SUBJECT: CERTIFICATION OF THE MINUTES FOR THE U.S. EPR  
SUBCOMMITTEE MEETING ON JANUARY 17, 2013,  
ROCKVILLE, MARYLAND

ADVISORY COMMITTEE ON REACTOR SAFEGUARDS  
MINUTES OF THE ACRS US-EPR SUBCOMMITTEE MEETING  
JANUARY 17, 2013

The purpose of the meeting was to hear presentations and discuss the information contained in Chapter 3, "*Design of Structures, Components, Equipment, and Systems*," except for Section 3.7, "*Seismic Design*," and Chapter 14, "*Verification Programs*," of the Safety Evaluation Report

Figure 3.8-1 — {Schematic Site Plan of Seismic Category I Buried Utilities (Electrical Duct Banks)}

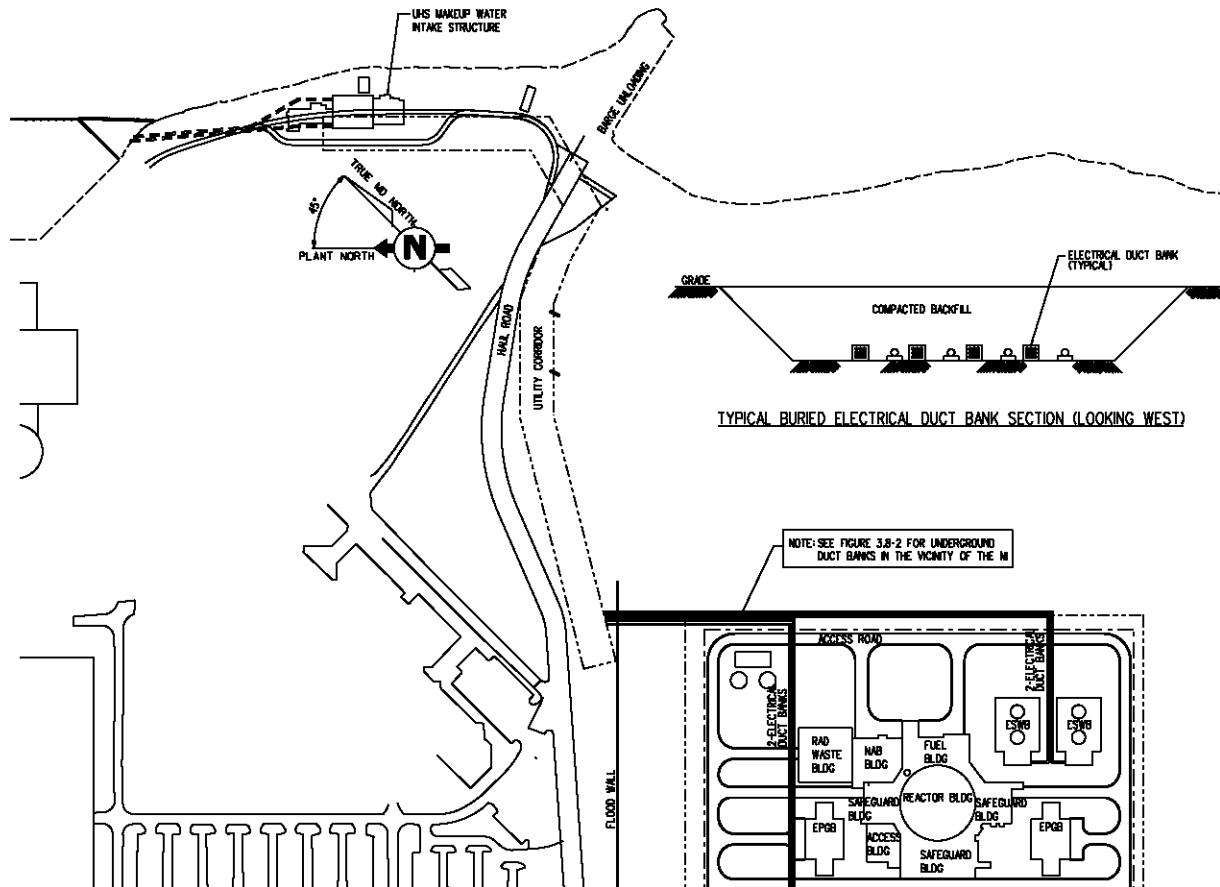
The members had questions regarding the buried electrical duct banks and requested a picture of that duct bank to better understand its configuration. The applicant provided a diagram and the members were satisfied with the applicant's response.	52-53
The applicant stated that they will basically install a waterproofing system that will protect any portions of the powerblock structures that are below that water table level. The applicant further stated that it will be essentially an impermeable boundary that prevents the water table from intruding toward the concrete of the safety structures. Member Ryan asked how are these areas going to be protected from infiltration and surface water? Member Ryan commented that they have structures in an unsaturated zone and a saturated zone and what the applicant explained was the saturated zone interaction. Member Ryan wanted to know about the unsaturated zone interaction as well? The applicant responded that two or three feet away from the concrete structure they plan to have an impermeable barrier, or waterproof barrier, and monitoring wells within that two or three feet, which will demonstrate that the area stays dry. The applicant also commented that they will also have the capability to dewater if necessary. Member Ryan asked "What's the typical infiltration in terms of inches per year in this area?" The applicant responded that they would provide Member Ryan more information during future discussions.	63-64

6 But Applicant has yet to provide comparable design  
7 information for buried duct banks, electric duct banks,  
8 and the pipes which is an open item.

1 MR. RAO: Based on RAI response we have  
2 provided which is RAI 333, provides a cross-section of  
3 the duct bank and details regarding the duct bank. The  
4 RAI response was essentially submitted.

4               MR. PARK:     My name is Sunwoo Park,  
5       structure engineer, Structure Engineering Branch. I  
6       have reviewed this section and we identified that there  
7       is a duct bank drain, a six-inch drain pipe indicated  
8       in the drawing provided as part of a RAI response from  
9       the Applicant.
